10 March 2022  
Ref 20417

**SSD-15882721**  
**PROPOSED MIXED USE DEVELOPMENT**  
**LOT 55 DP 1253217 – DORAN DRIVE PLAZA PRECINCT**  
**VEHICULAR ACCESS, ON-SITE LOADING & WASTE COLLECTION MATTERS**

I refer to your letter dated 14 September 2021 requesting additional information in respect to the abovementioned development proposal (SSD-15882721). The following advice is provided in respect of the matters raised under the ‘*Internal Traffic and circulation comments*’ – *Item 3* and ‘*Asset Management, Traffic and Parks*’ sections of your letter.

Ramp 4&5 Section  
1:100

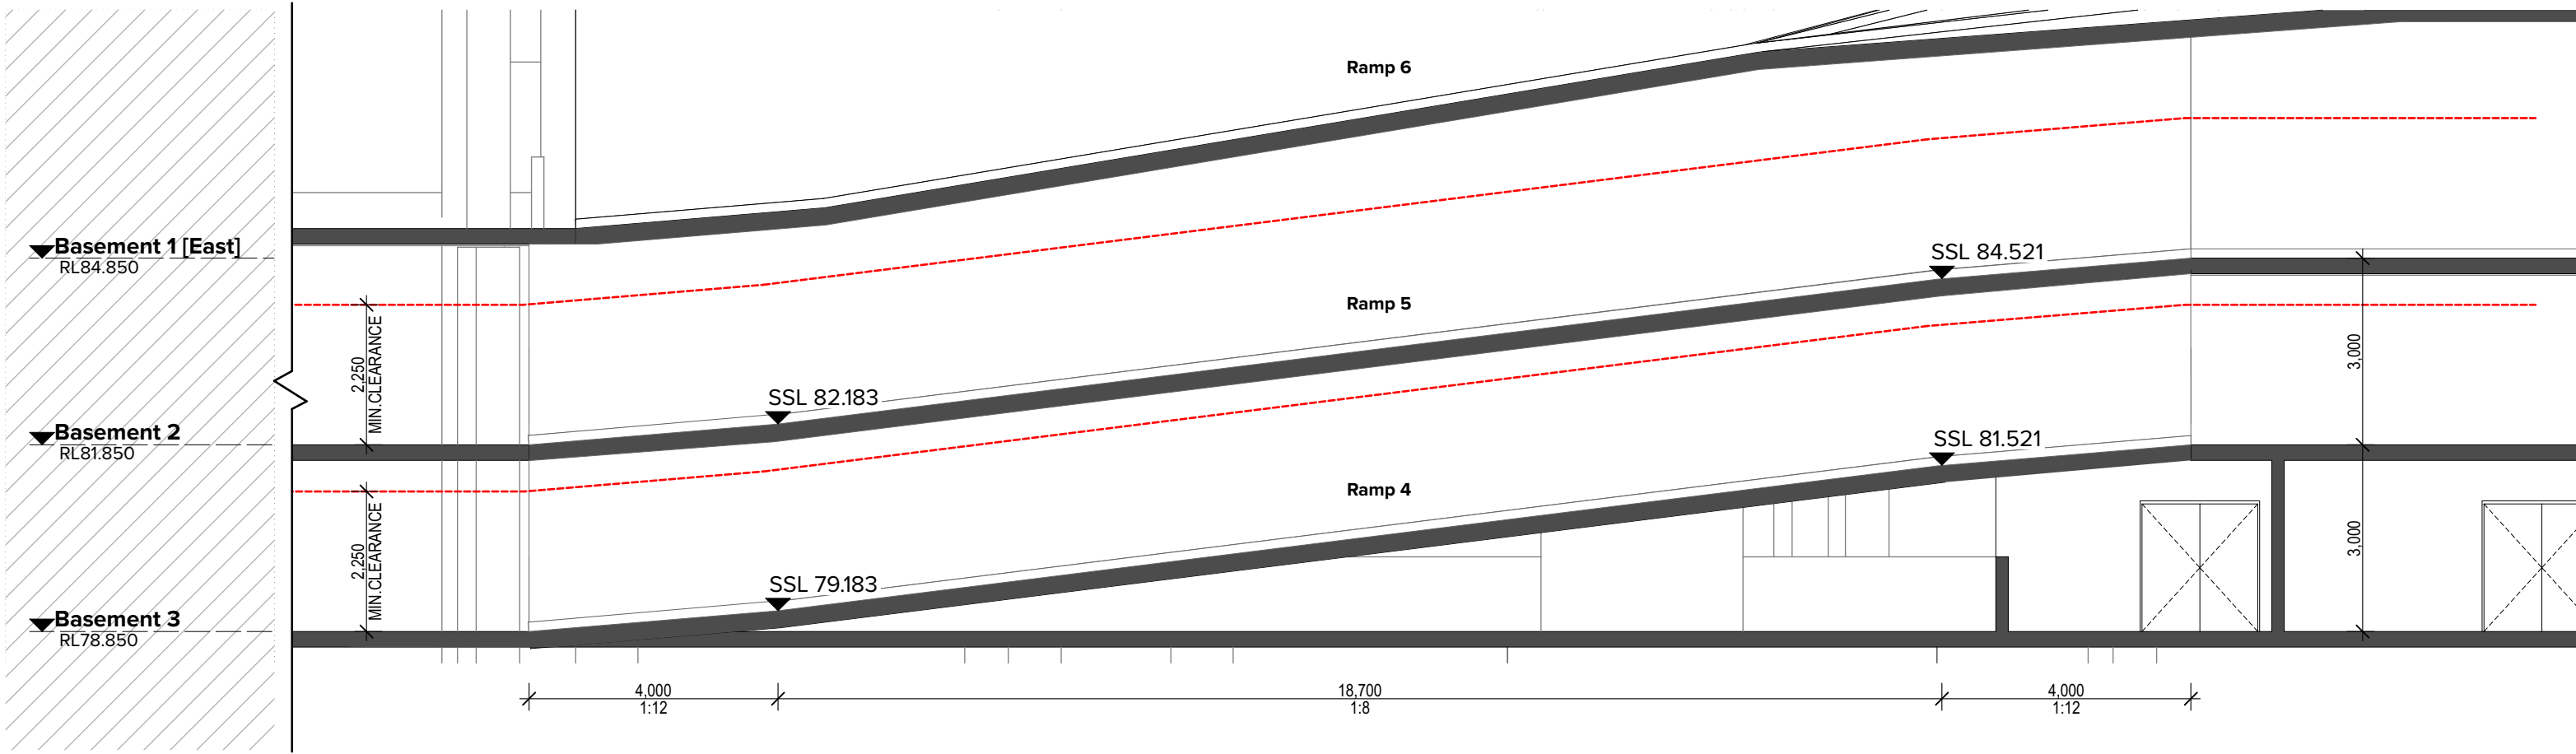
*“3.3. A cross section plan of driveways and ramps will need to be provided on plan; it must detail compliance gradient and changes of grade with the relevant AS/NZS 2890.1 and AS2890.2.”*

As requested, detailed cross section plans of the proposed basement access driveways and ramps have been provided and are attached. I can also confirm that the proposed ramp gradients and transition lengths comply with the relevant aspects of AS2890.1:2004. In particular it is noted that the ramp has been restricted with a maximum 1 in 5 (20%) grades, separated by 1 in 8 (12.5%) transitions, or less, in accordance with AS2890.1 requirements.

DRAWING TITLE  
 12.5M HRV TRUCK TURNING PATHS  
 Entering Andalusian Way from Carrington Road  
 ADDRESS  
 Doran Drive, Castle Hill

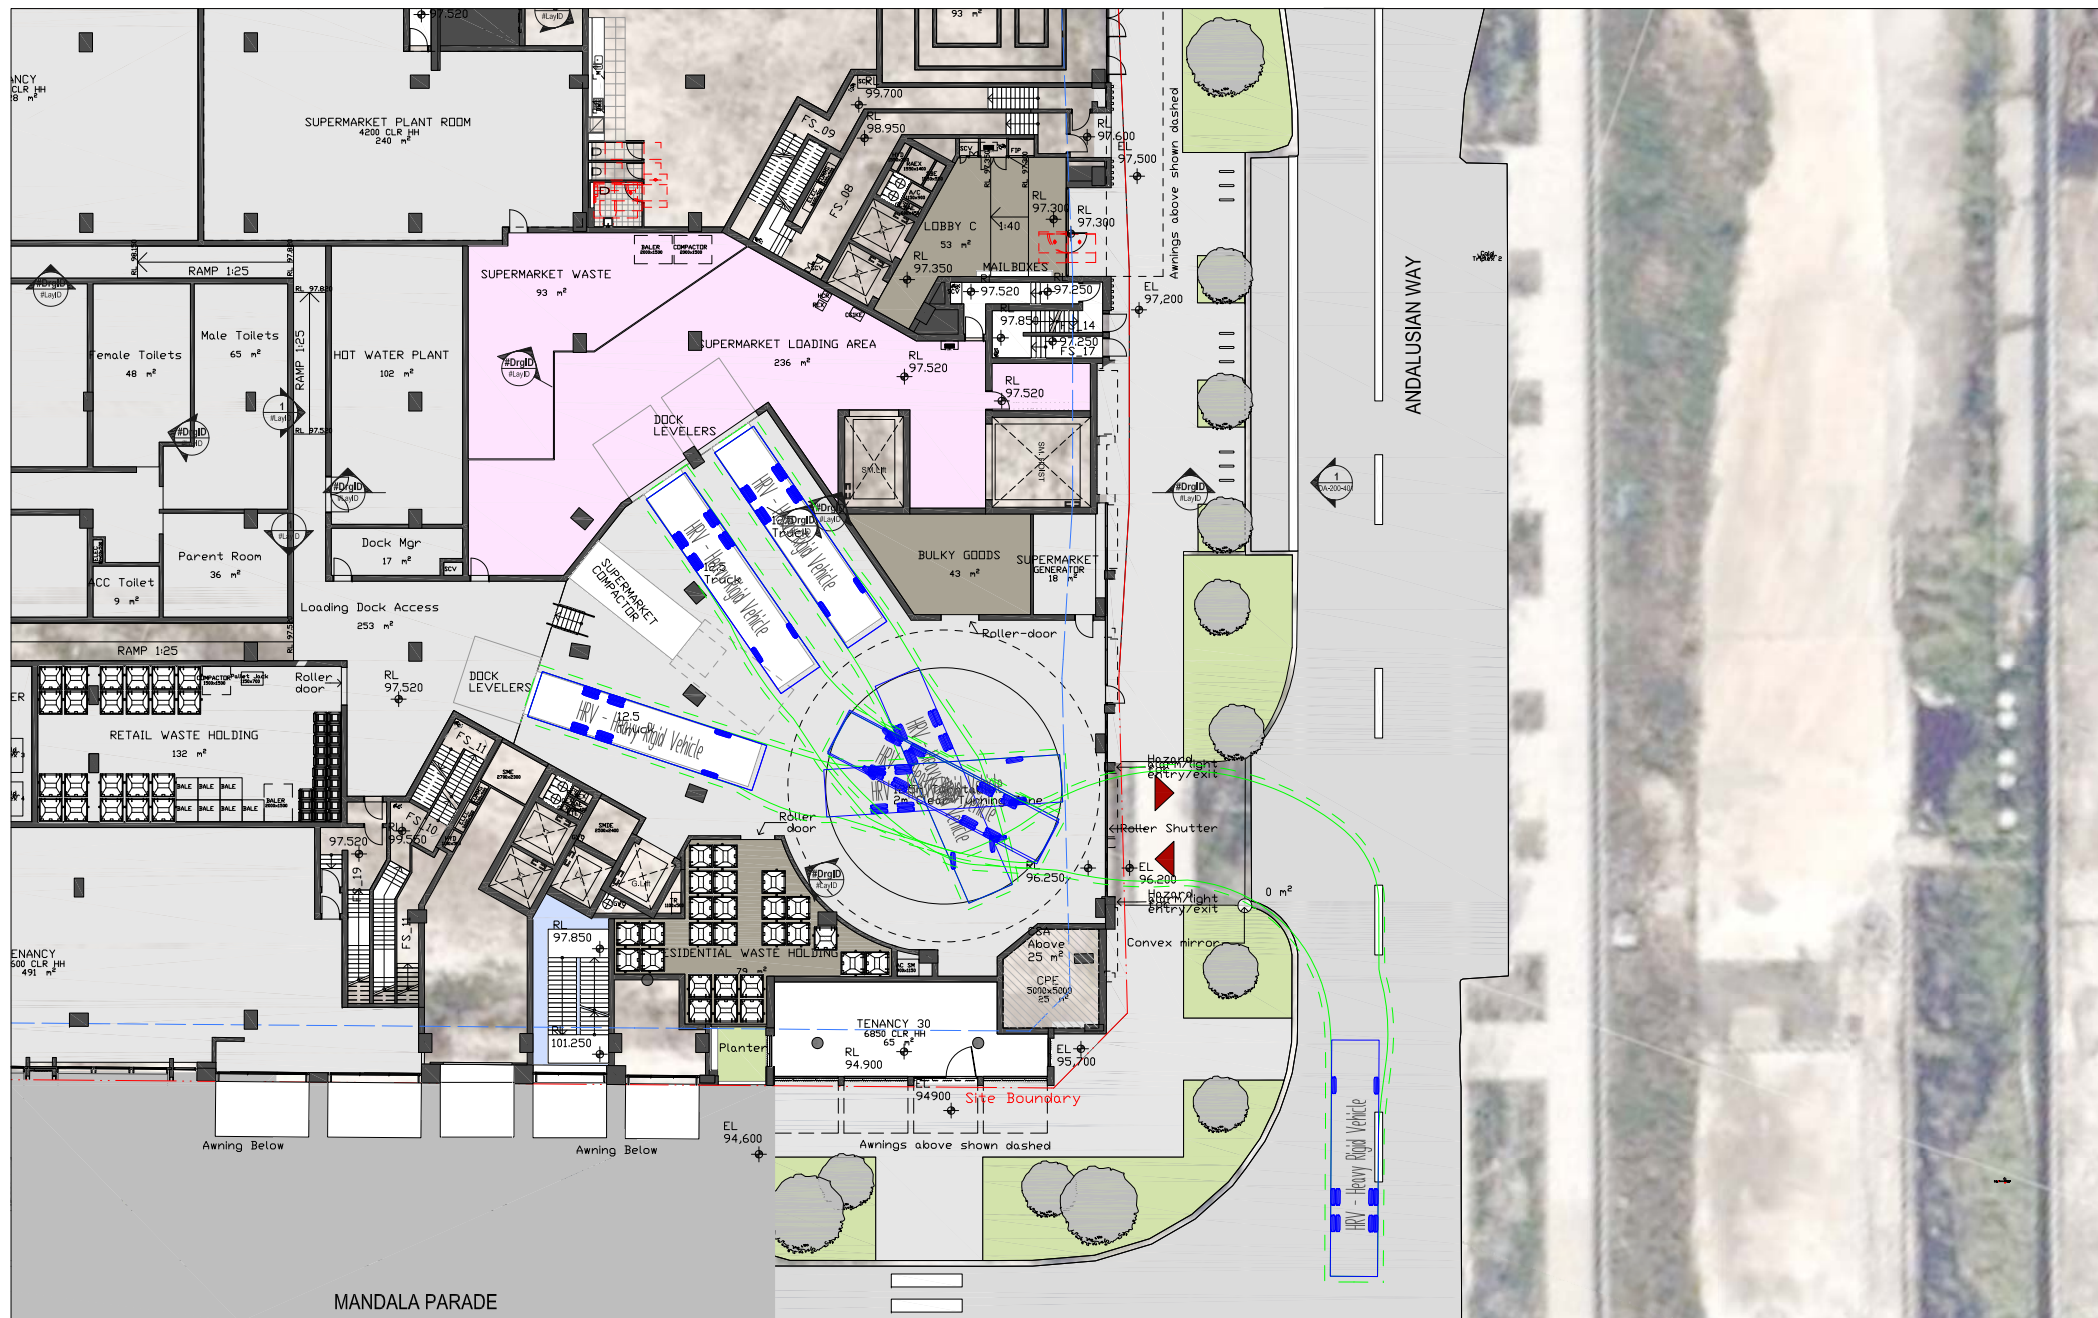
*“If new services are required in Carrington Road, please contact Council’s Infrastructure and Transport Planning section for proposed surface levels to assist with their placement.”*

As demonstrated by the *swept turning path* diagrams, no road upgrade works are required as a consequence of the development proposal, with the existing Carrington Road/Andalusian Way intersection capable of accommodating the 12.5m HRV trucks.

**DRAWING TITLE**  
 12.5M HRV TRUCK TURNING PATHS  
 Entering Dedicated Loading Dock Area  
**ADDRESS**  
 Doran Drive, Castle Hill

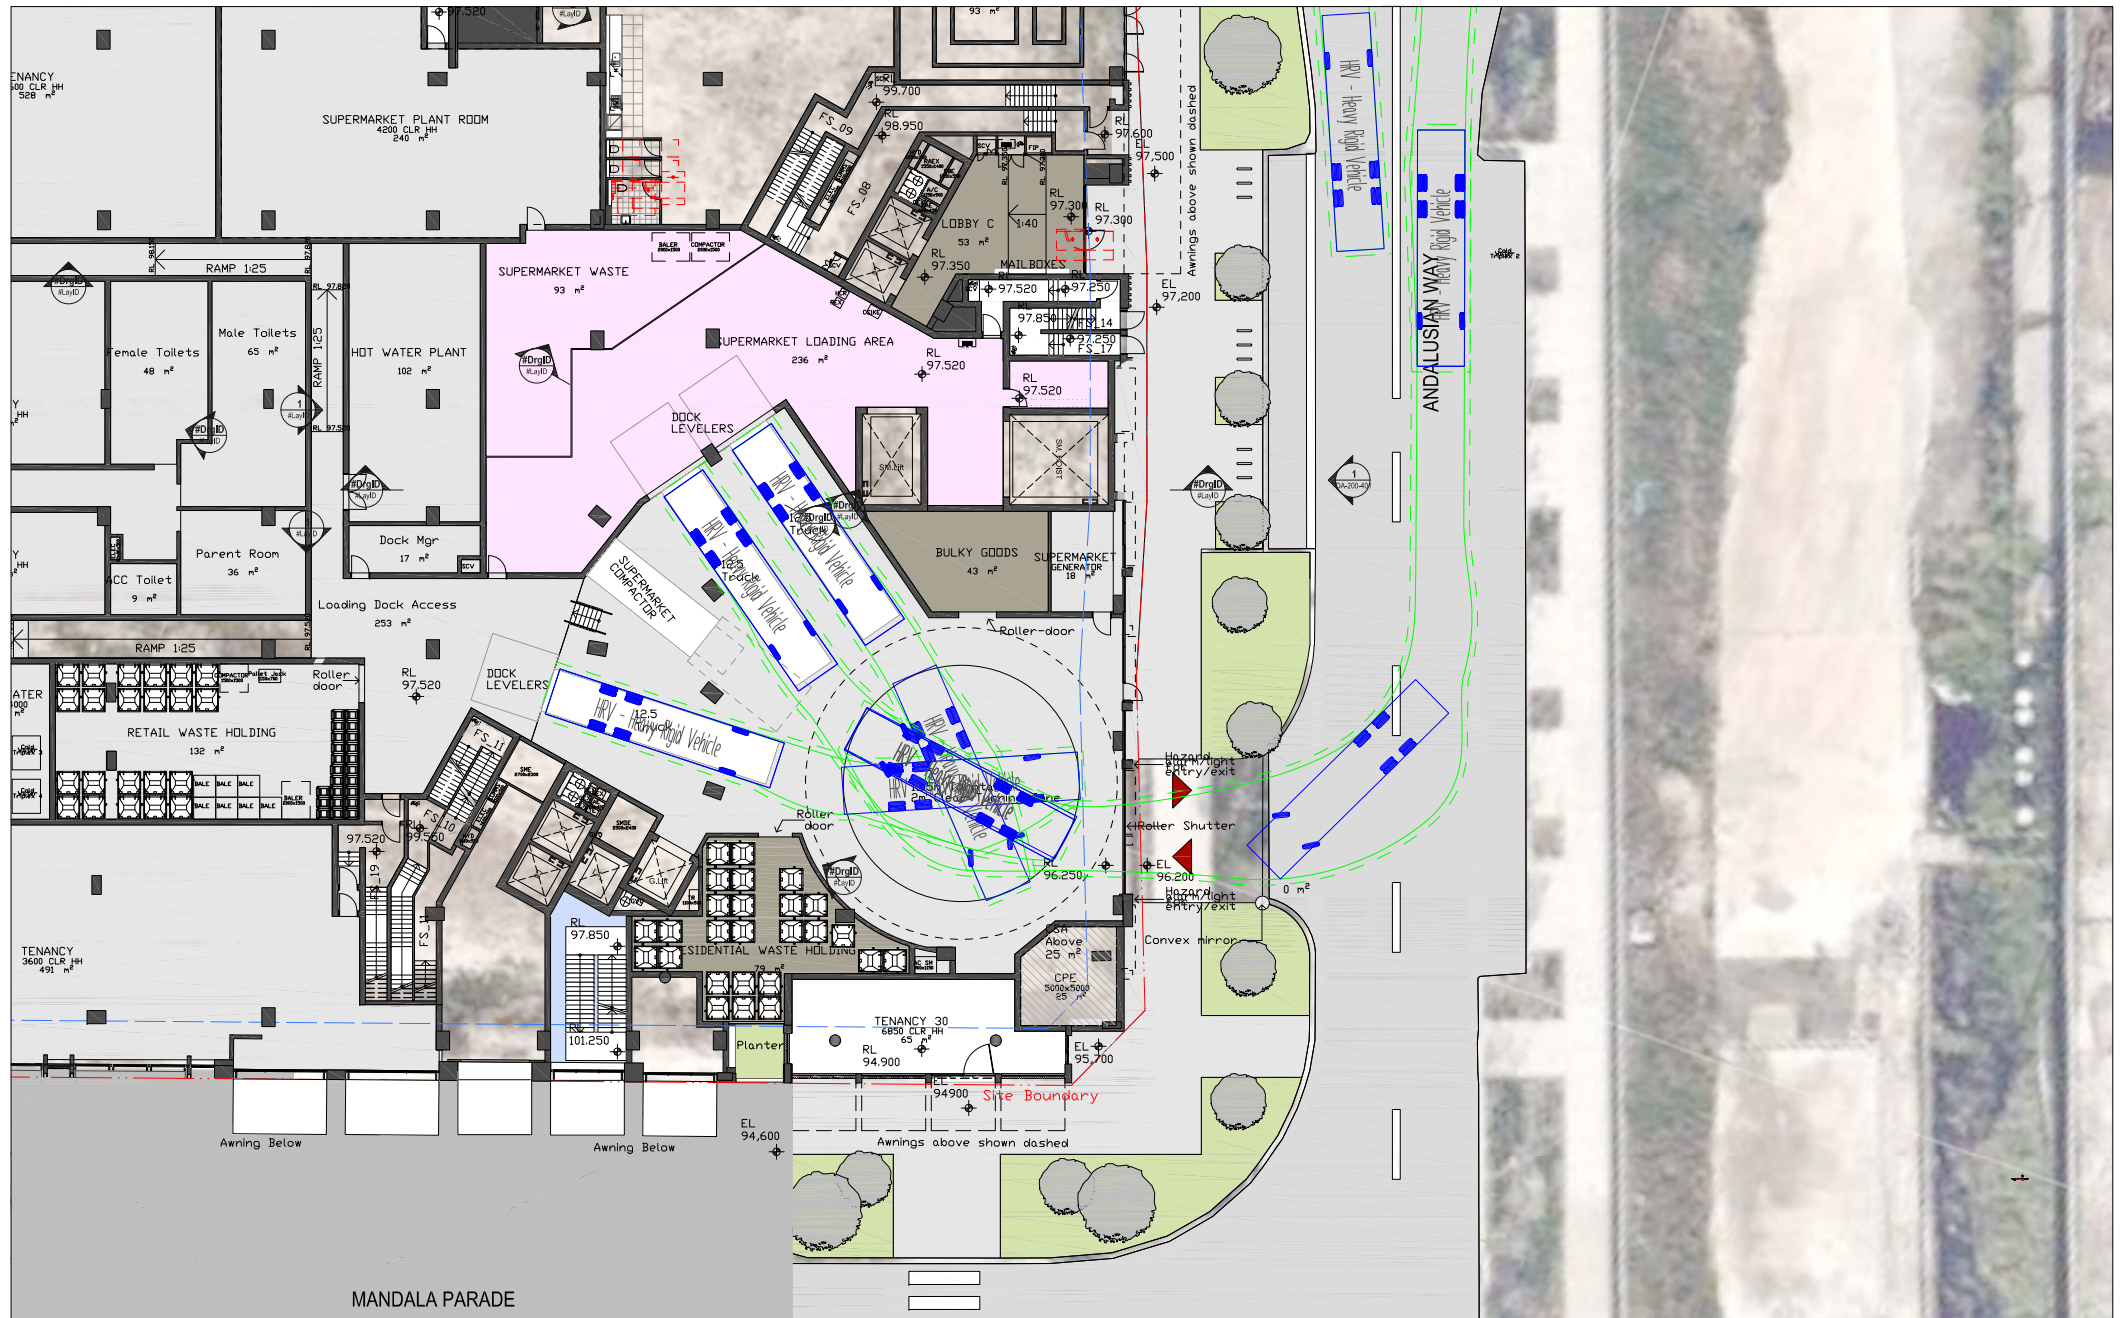
*“Turning path diagrams shall be provided to demonstrate that a 12.5m Heavy Vehicle can turn left from Andalusian Way into the loading dock safely.”*

As requested, we have prepared 12.5m HRV swept turning paths for vehicles accessing the loading dock.

The swept turning path diagrams were prepared using the Autodesk Vehicle Tracking 2022 program in accordance with the requirements of AS2890.2:2018, and confirm that the HRV trucks will be able to enter and exit the site in a forward direction at all times as well as *turn left from Andalusian Way into the loading dock safely*.
